# Video Products Technical Bulletin 30-2003-214

SUBJECT: **MANUAL CORRECTION—FLYBACK  
TRANSFORMER ASSEMBLY**

MODEL: **PVM-14M2MDU**  
***PVM-14M2MDE***  
***PVM-14M2MDA***  
**PVM-20M2MDU**  
***PVM-20M2MDE***  
***PVM-20M2MDA***

**Figure 1**

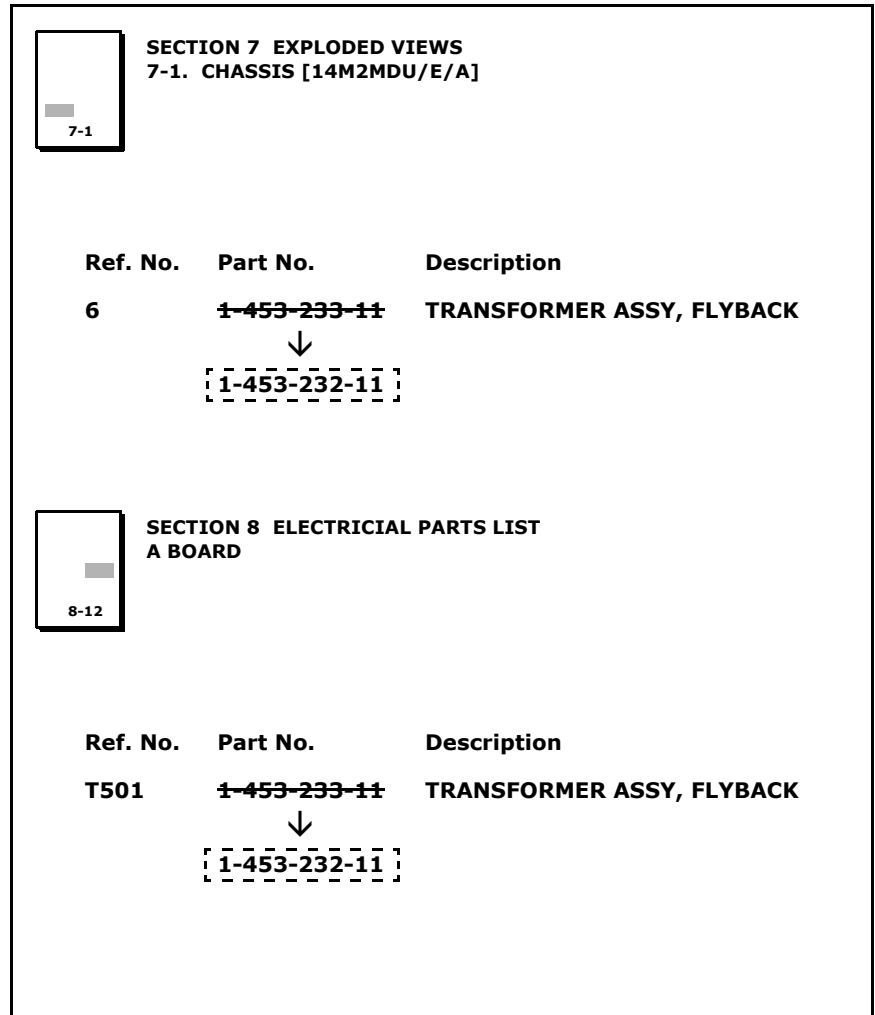
Correct the *PVM-14M2MDU/14M2MDE/14M2MDA/20M2MDU/20M2MDE/20M2MDA Service Manual* as shown in Figure 1.
